2013 PERRY NUCLEAR POWER PLANT

INITIAL LICENSE EXAMINATION

SUBJECT:
Perry Nuclear Power Plant
NRC Post-Examination Material, Perry License Class 1-LOT-13

Perry Nuclear Power Plant Comments

QUESTION RO 40

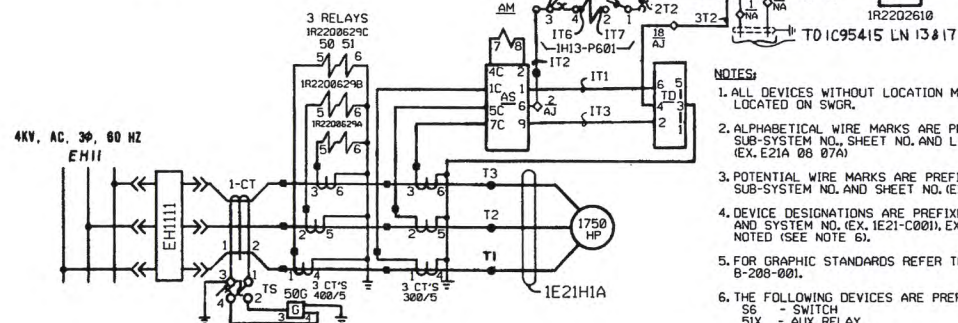
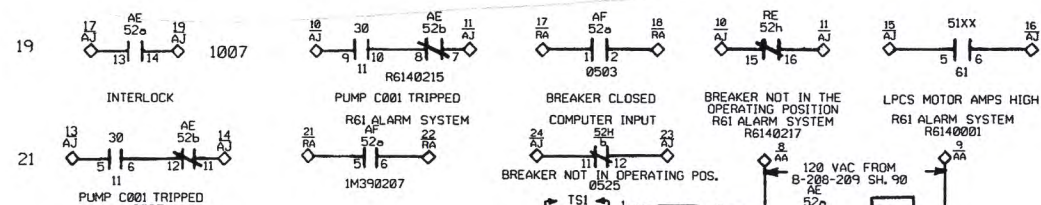
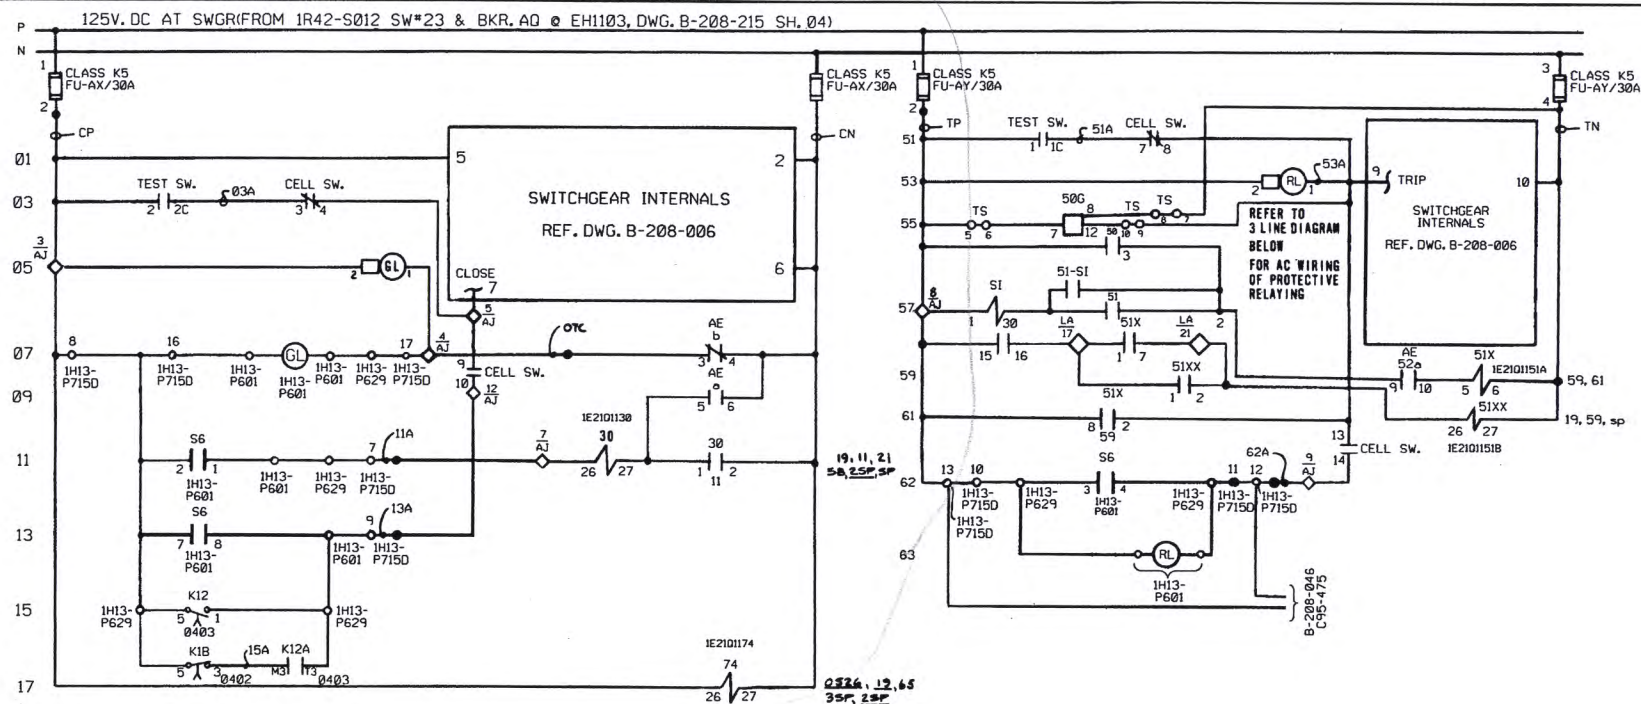
1. The question asks how the LPCS pump will respond following a LOOP/LOCA actuation signal if the pump initiation logic had been previously overridden.
2. The answer key incorrectly lists distracter 'A' as the correct answer
3. Per plant drawings 208-0060-00004 revision AA and 208-0060-00008 revision DD the LPCS Override Logic Seal-in will de-energize during a Loss of Offsite Power and when power is restored the LPCS pump will automatically restart with no time delay
4. Amend the answer key to list distracter 'B' as the correct answer

- A. Incorrect answer – The LPCS pump will automatically restart, the override seal-in logic de-energizes during a LOOP
- B. Correct answer – The LPCS pump will automatically restart without time delay
- C. Incorrect answer – The LPCS pump will automatically restart without time delay, 10 seconds is the time allowed for the DG to energize the bus.
- D. Incorrect answer – The LPCS pump will automatically restart without time delay. The 15 second time delay is for a LOCA only without a LOOP.

Recommendation: Amend the Answer Key to list 'Answer B' as the correct answer.

6.0 FIGURE #4 HEAT CAPACITY LIMIT

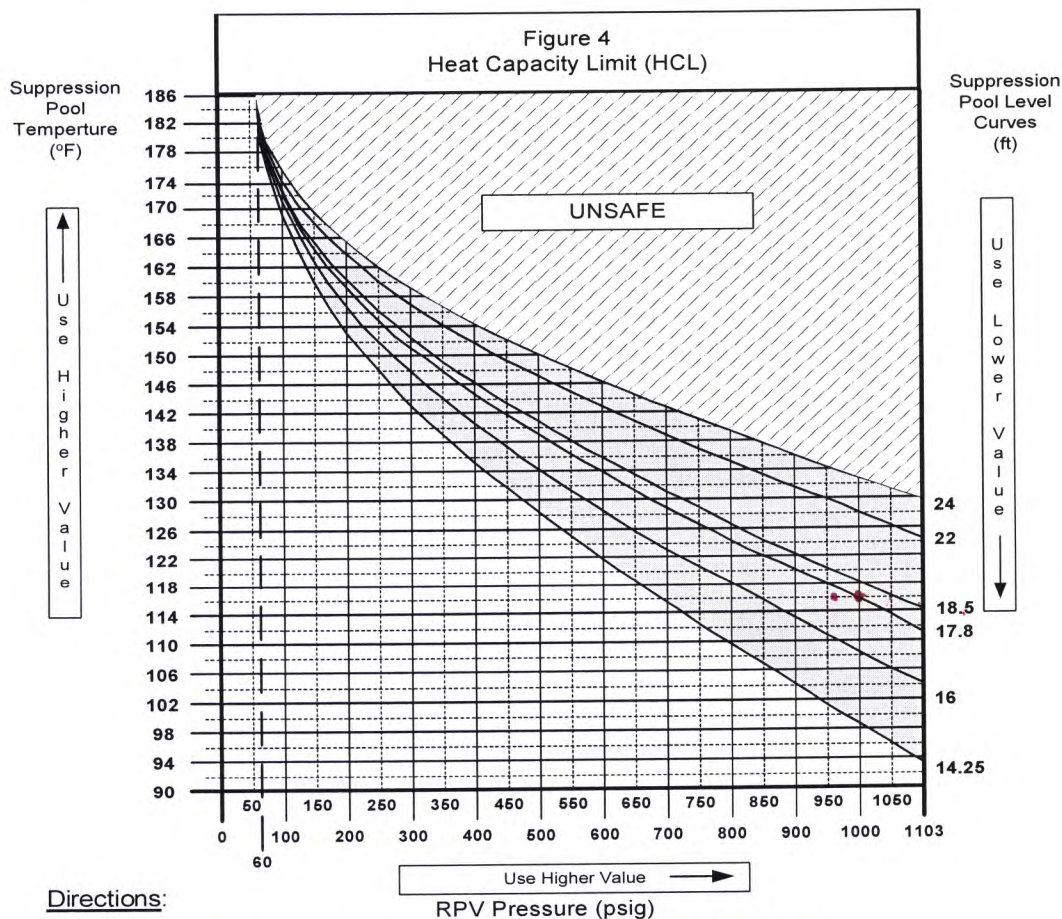
- Though the EOP-SPI Supplement Figure 4 was not given to the students, if one were to plot the given conditions on Figure 4, HCL would already be in the UNSAFE region requiring immediate Emergency Depressurization (ED) per EOP Bases, EOP-1A, EOP-2 and Hardcards (OAI-1703).

- The deteriorating challenge also includes a lowering Suppression Pool Level due to a pipe break of unknown size or unknown level change rate. Figure 4, Heat Capacity Limit, shows that as Suppression Pool Level lowers, HCL is further challenged as there is less water to absorb heat causing heatup rate to raise more.

Step LPC/P-2 states that if HCL cannot be maintained below the limits of Figure 4 then the operator is directed to maintain RPV pressure below the HCL limit. As stated in the candidate's response the normal pressure band directed is 5 to 10 °F below HCL. The information given in the stem indicates that there is currently only 3 °F margin to HCL therefore the first appropriate action directed by the Unit Supervisor is to open additional SRVs to restore within the assigned pressure band. It is true that a lowering suppression pool level due to a leak adds another layer of complexity however Emergency Depressurization due to lowering suppression pool level is required before 14.25 feet and the stem provides information that this level is not currently challenged.

In addition EOP Step STC-5 requires Emergency Depressurization when HCL cannot be restored and maintained below the limits of Figure 4. EOP Bases defines Restore and Maintain as taking actions using available systems to restore a parameter to within a desired band or condition and maintain it there which includes actions to bring on additional equipment. Definition includes a note that states a parameter can be considered to be restored and maintained even if the parameter exceeds the limit multiple times as long as the majority of the time is spent within the limit.

With the conditions stated in the stem there are additional actions that can be taken to restore and maintain RPV pressure within the limits of HCL, Figure 4 and should be directed first by the Unit Supervisor which requires opening an additional SRV to lower RPV pressure.
